DE LOREAN MOTOR CARS OF AMERICA  
Division of DeLorean Motor Company

# SERVICE BULLETIN

NUMBER ST-06-9/82

CATEGORY: TECHNICAL  
ATTENTION: ALL DMC DEALERS/SERVICE MANAGERS  
SUBJECT: TEMPORARY WIRING MODIFICATION - FAN FAIL  
MODULE

fig 1 COOLING FAN CIRCUIT

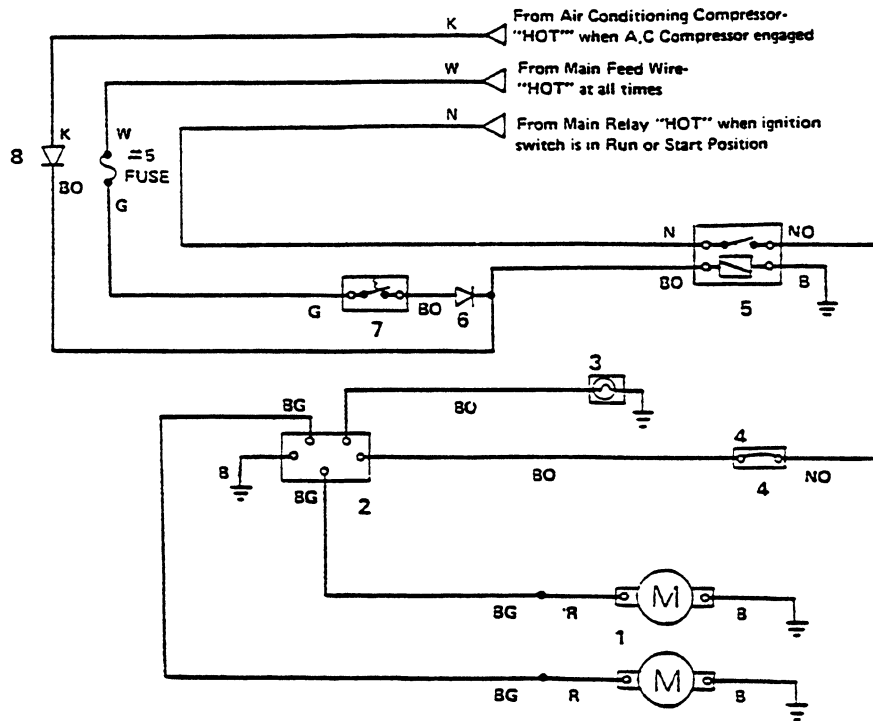
It is important to positively determine that the fan fail module is defective prior to installing this link wire assembly. A check should be made on the cooling fans to ensure they have not seized. The entire engine cooling fan circuit and components must also be checked for continuity and operation with special attention to all connections (Figure 1).
